RE: Kyle Canyon Gateway Unit 4 - Justification Letter for a Major Modification, Vacation, Zone Change, Site Development Review and Tentative Map

Major Modification to the Development Plan and Development Standards Justification

Revised exhibits from the Design Guidelines are included with this submittal. The revision to the exhibits includes the addition of the parcels to the planned development area as well updates to the street network, street sections, and wall height tables. The street network was updated to remove the street connection on Michelli Crest Way from Ruston Rd to Trails End Ave, to specify certain dimensions as minimum, and to specify the use of dead ends (Exhibit 5.T.1). The street section on page 68-70 of the updated guidelines were also updated to reflect the minimum dimensions and to add a dead-end street section (Exhibit 5.T.2, 5.T.3, 5.T.4). The wall height tables were updated to clear up conflicting information on the tables (2.A.1, 2.A.2, and 2.A.3). The wall height tables

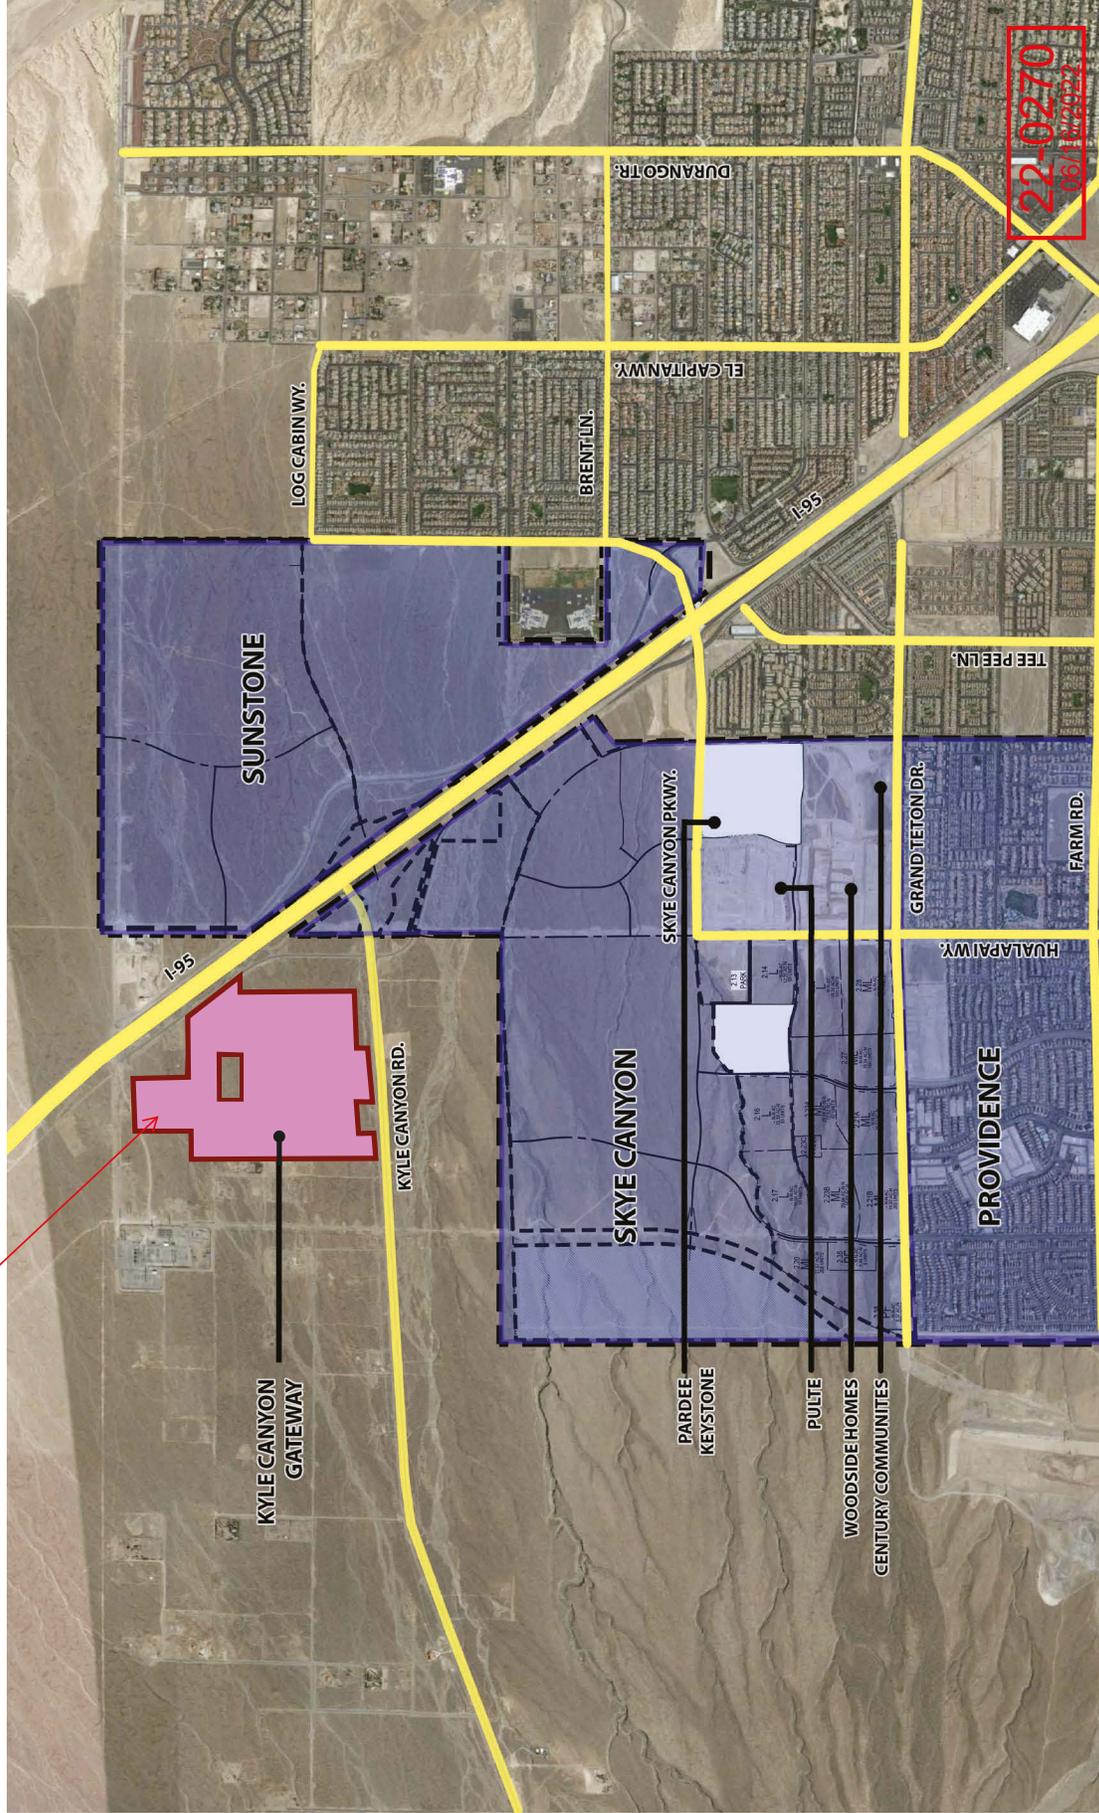
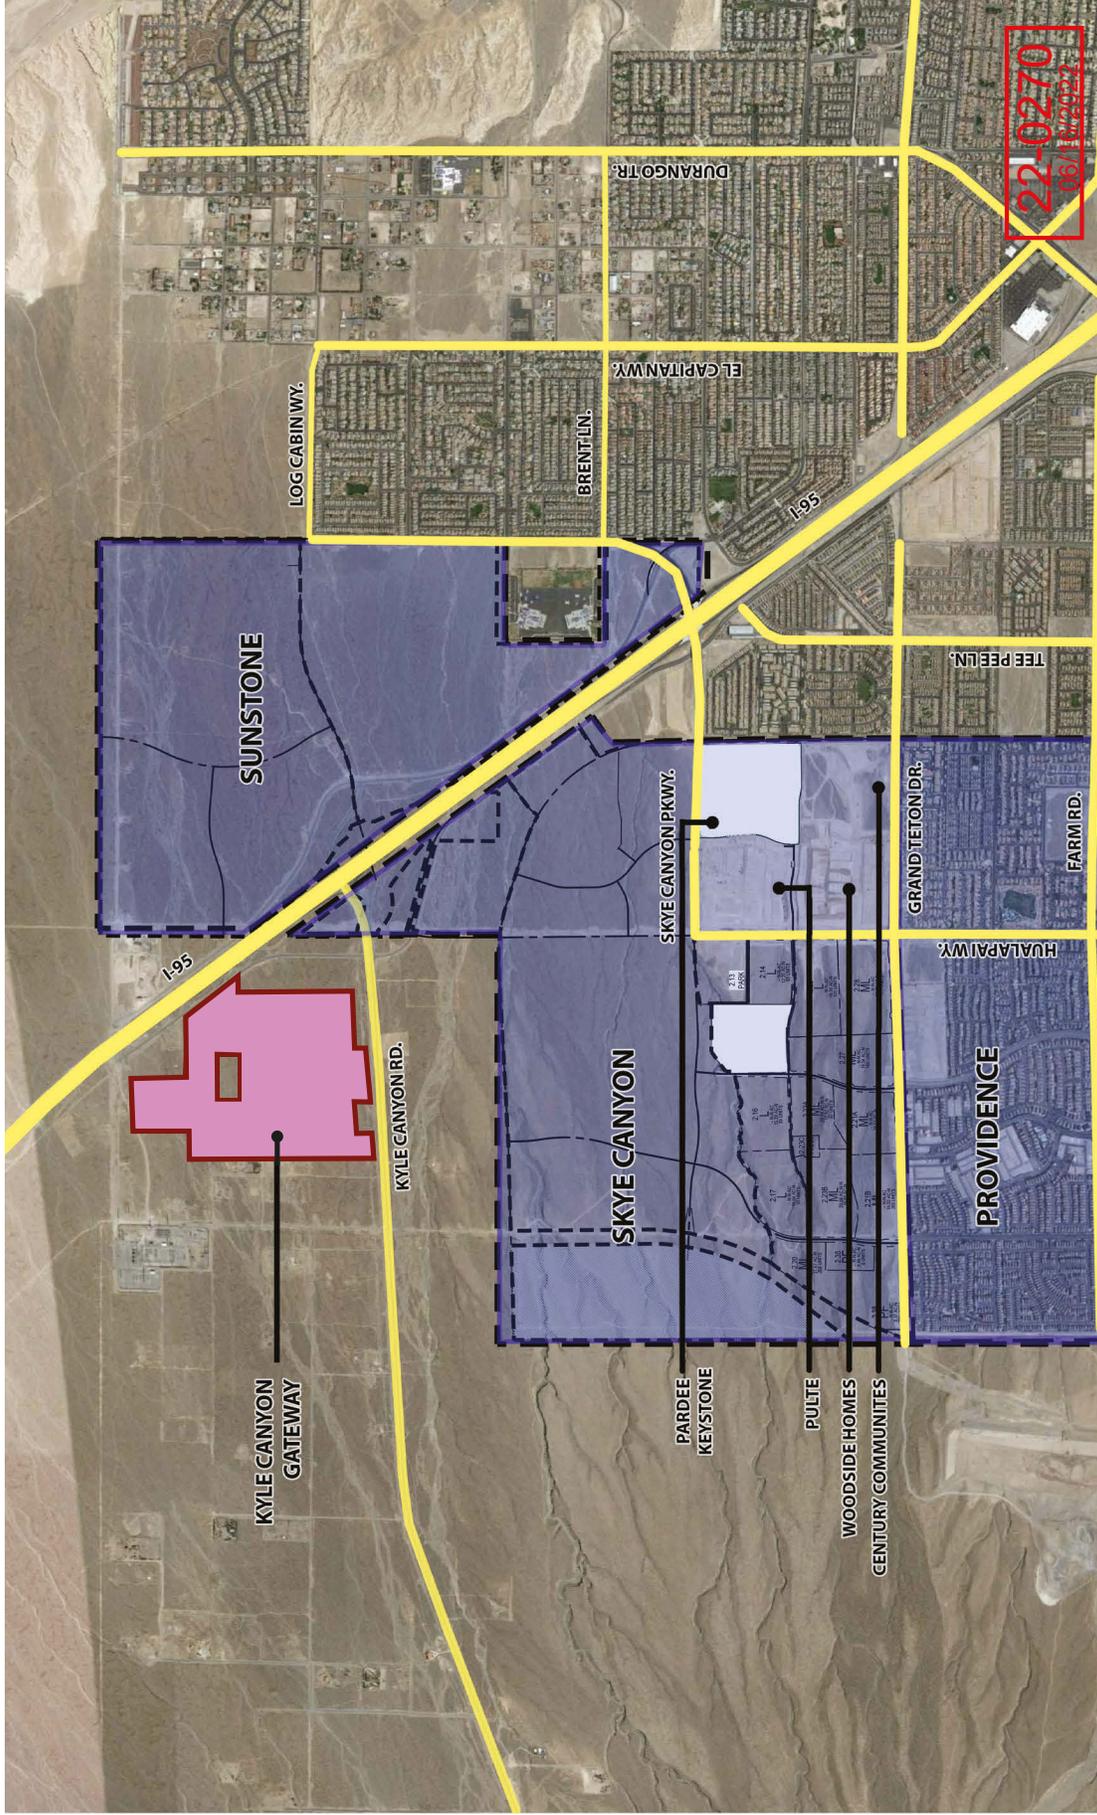
Updated map

EXHIBIT 5.T.2: STREET SECTION - PRIVATE STREETS

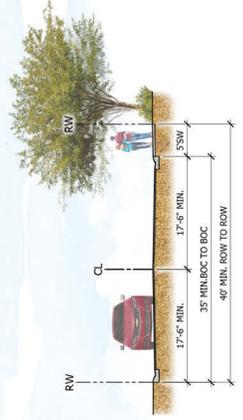
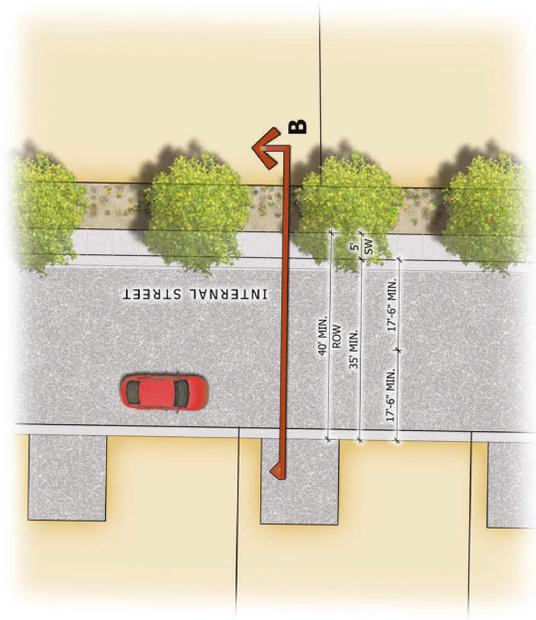
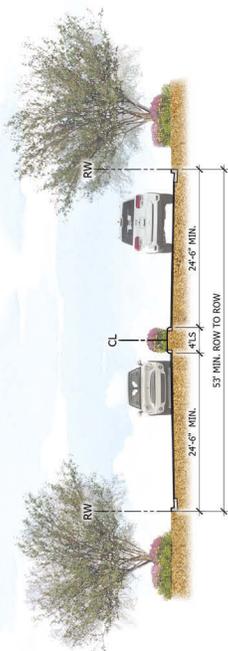
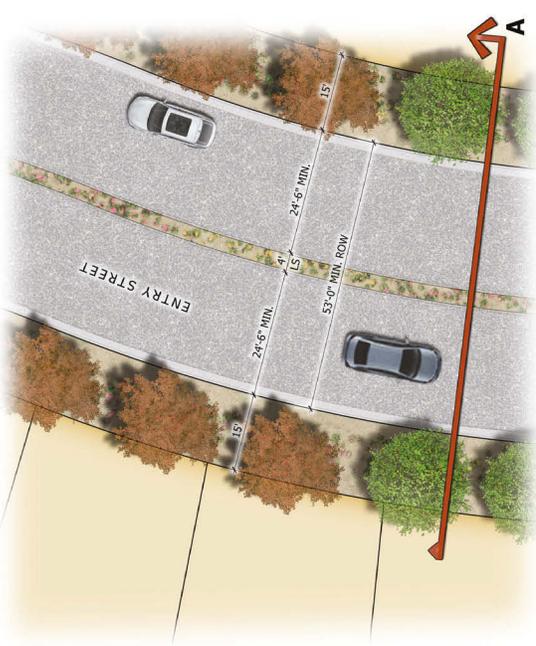
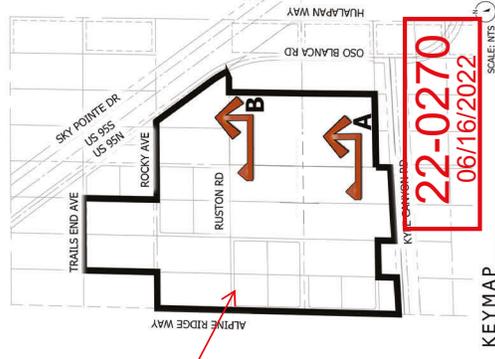
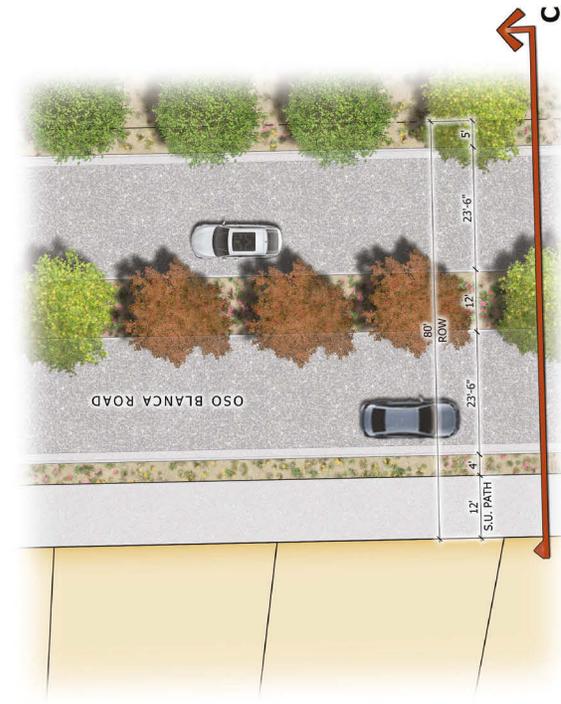
MIN ADDED ON CROSS SECTIONS

Updated Keymap

EXHIBIT 5.T.3: STREET SECTION - PUBLIC STREETS

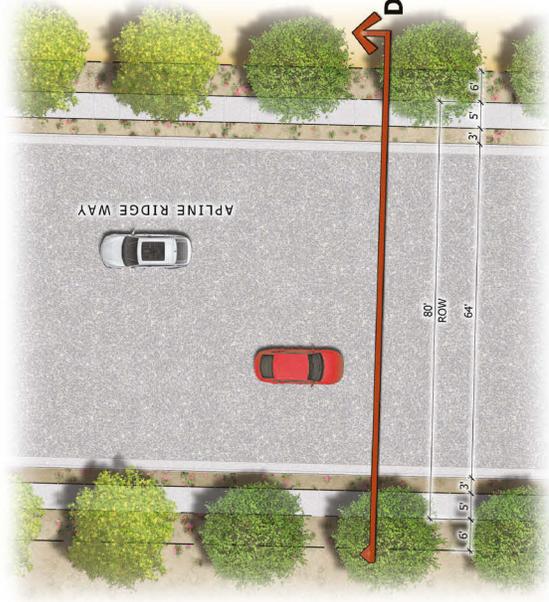
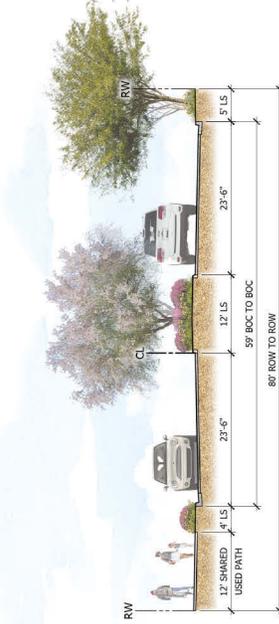
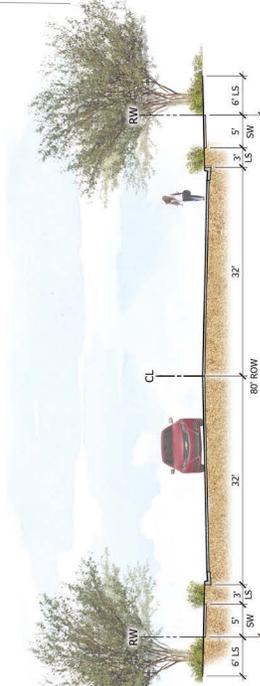
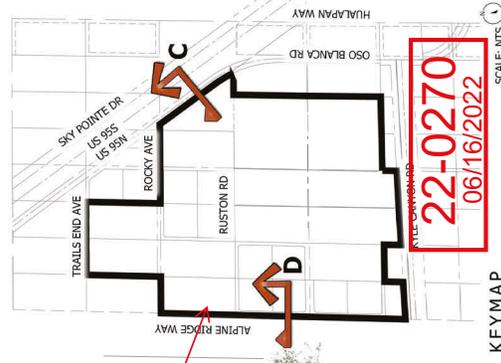
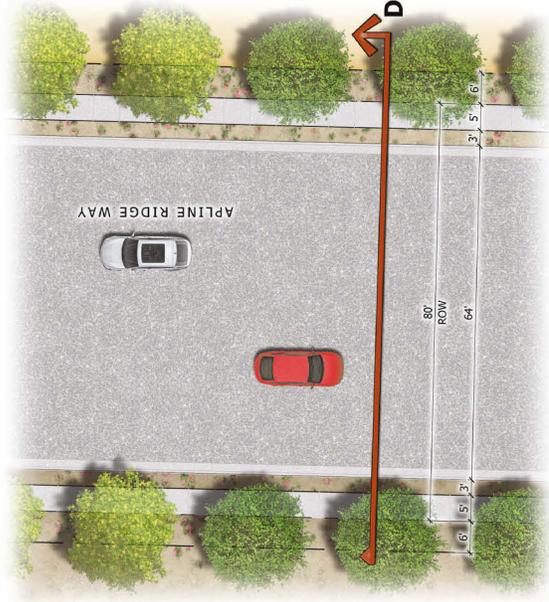
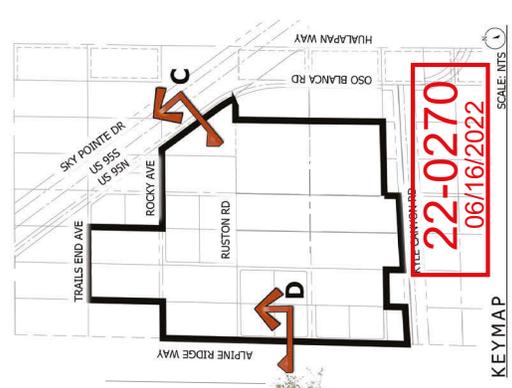
MIN ADDED
ON CROSS
SECTIONS

Updated Keymap

EXHIBIT 5.T.4: STREET SECTION - 60' PUBLIC STREET

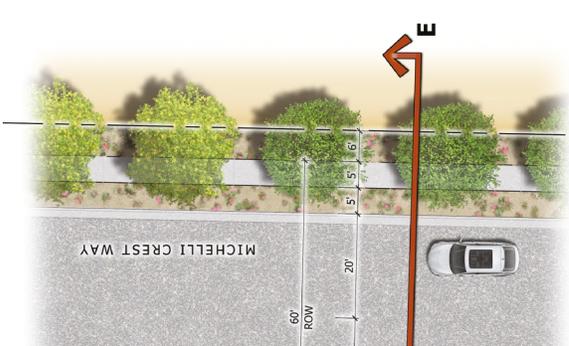
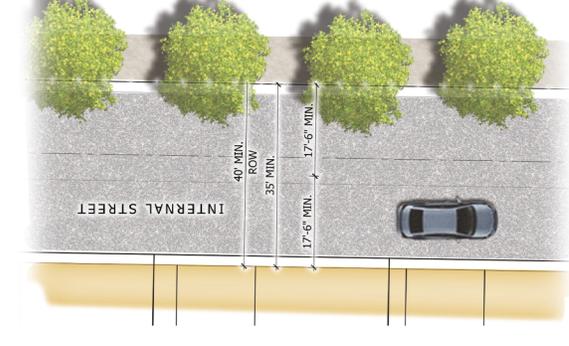
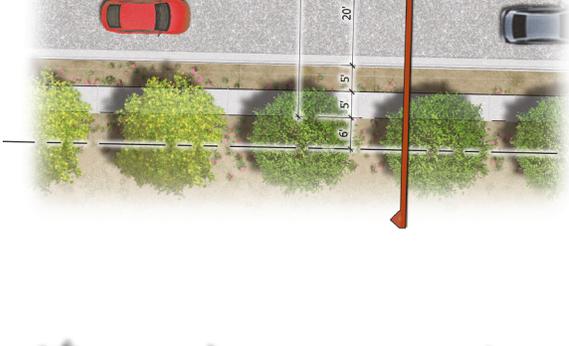
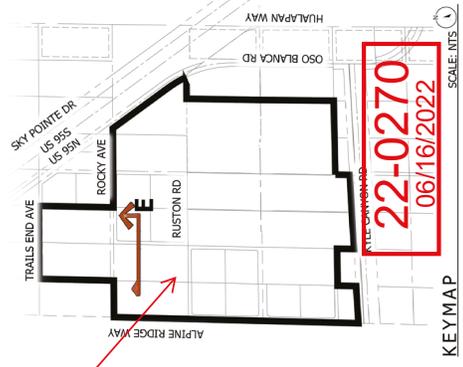
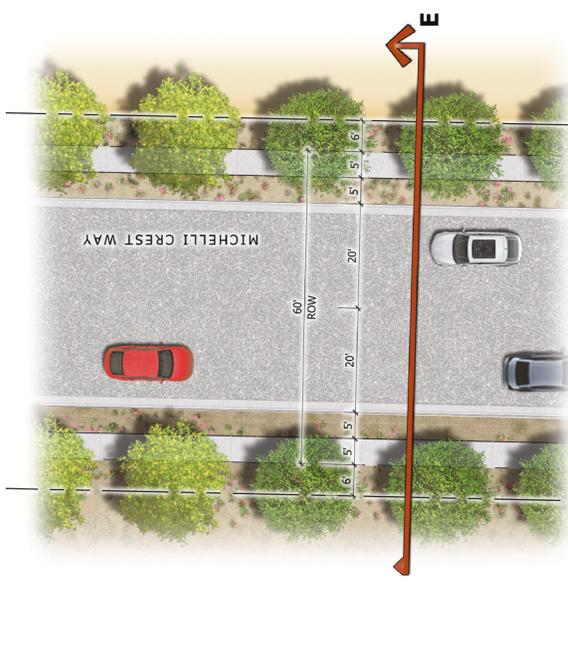
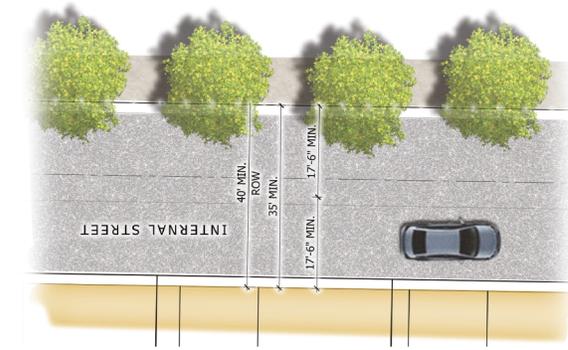
MIN ADDED ON CROSS SECTIONS

SECTION ADDED TO DISPLAY DEAD-END STREET DISPLAYED ON EXHIBIT 5.T.1
